**Our Case Number:** ABP-314724-22

**Re:** Railway (Metrolink - Estuary to Charlemont via Dublin Airport) Order [2022]  
Metrolink. Estuary through Swords, Dublin Airport, Ballymun, Glasnevin and City Centre to  
Charlemont, Co. Dublin

## **METROLINK TERMINUS at CHARLEMONT**

# Charlemont – D-Wall & Piling Phase

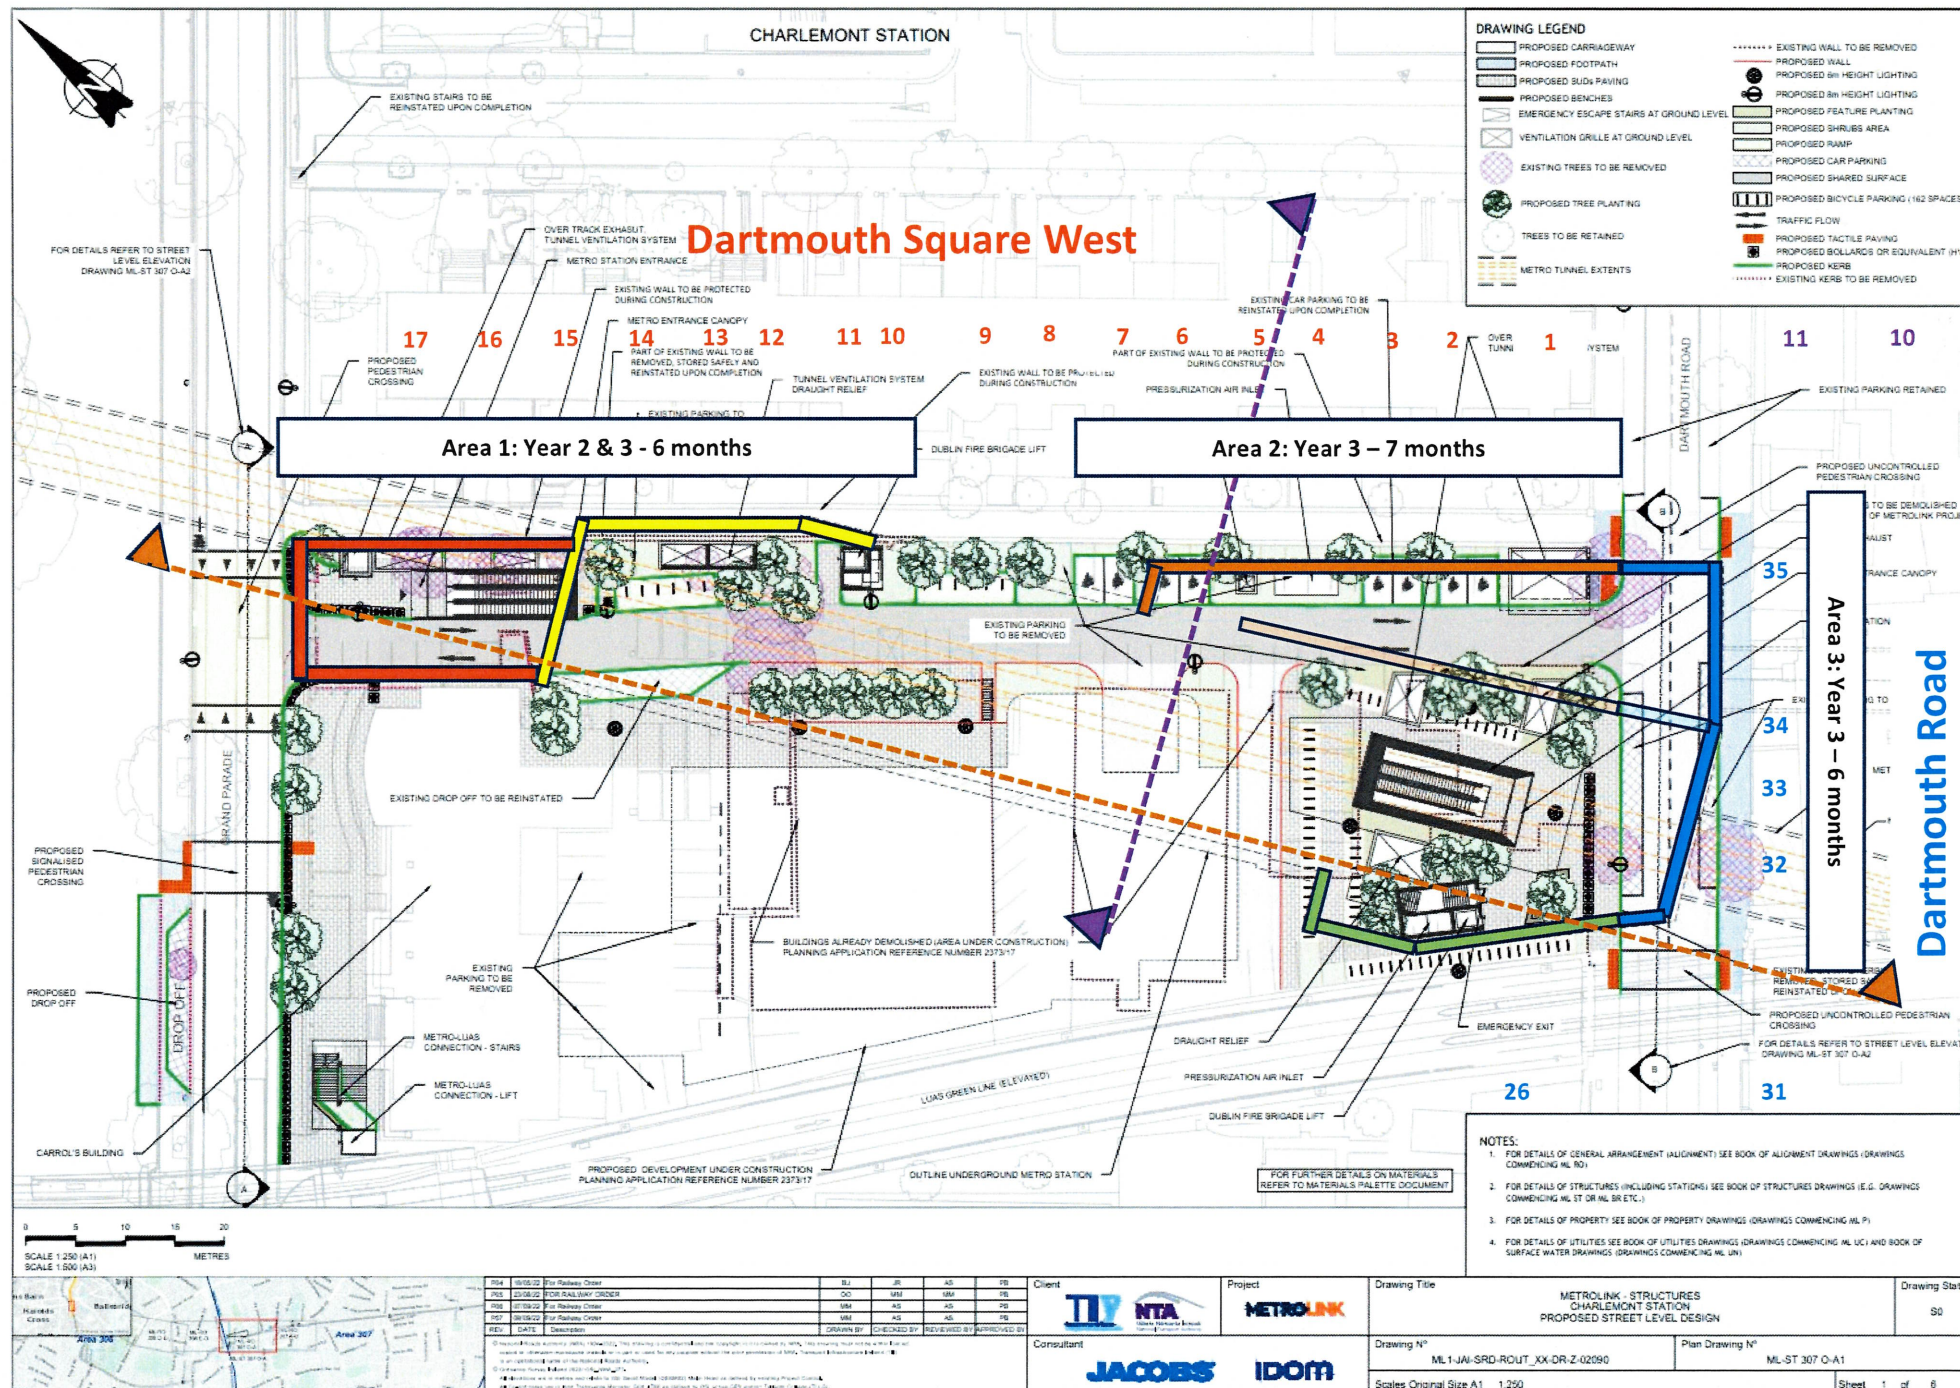
Immediately following my presentation to the OH on 26 March 2024, TII was invited to respond. What I heard has given me cause for very grave concern. This relates to the method of construction to be used in the building of the 'red wall' in the attached drawing which has been prepared by TII.

The drawing shows the walls of the terminus in various colours including, red, yellow, green and brown. The 'red wall' is a 30 x 30 metre trench at the northeastern corner of the site which is very close to our home # 15 Dartmouth Square and is also close our neighbours' homes at # 16 and 17. In fact, at its nearest point it is closer to # 15 than it is to any other home on the terrace. Consequently, I have a particular interest in understanding the risks of damage to our home involved in the construction of this wall.

TII's drawing indicates that secant piling will be used for the 'red wall' while the diaphragm wall construction method will be used for the other terminus walls. I went into some detail about this in my presentation to the OH on 26 March 2024.

In my presentation, I argued that if planning permission were to be granted for the terminus at Charlemont, the ABP should make it a condition of the permission that the D wall (diaphragm wall) construction method be used in the construction of this 'red wall'. I outlined how I and other neighbours had met with senior members of the TII team (including James Maloney, Ronan Hallisley and Aiden Foley) in the basement of the Gresham Hotel on 12 March 2024. This meeting took place 'after hours' at the OH. James Maloney provided a detailed and technical description of the D wall construction method which my neighbours and I understood would be used in the construction of the 'red wall'. He explained the difference between this construction method and the secant piling method.

At that meeting the TII accepted that the D wall construction method was more efficient than the secant piling method in excluding water ingress which could cause ground settlement and in turn could result in damage to our homes which were protected structures. James Maloney confirmed that most of the terminus would be constructed by the D Wall construction method – and that the 'red wall' was the exception.

We made a strong case that if the D wall construction method was the favoured construction method elsewhere on the site, then it should also be specified for the 'red wall'. TII owed the same duty of care to all the homeowners along the terrace on the west side of the Square. If the D wall construction method is acknowledged to be 'more efficient' in excluding water ingress, and therefore poses a lower level of risk of ground settlement and damage to our homes, then it should be used in construction of the 'red wall'.

- The construction method of the 'red wall' – the 30 x 30 metre trench at the northeastern corner of the site - be specified as Diaphragm wall construction method.
- TII providing an indemnity and guarantee to pay for structural damage to homes 1 – 17 on the west side of Dartmouth Square as a result of the building works on the site.
- TII demonstrating to ABP the effectiveness of the noise barrier wall in mitigating the airborne noise emanating from the site.
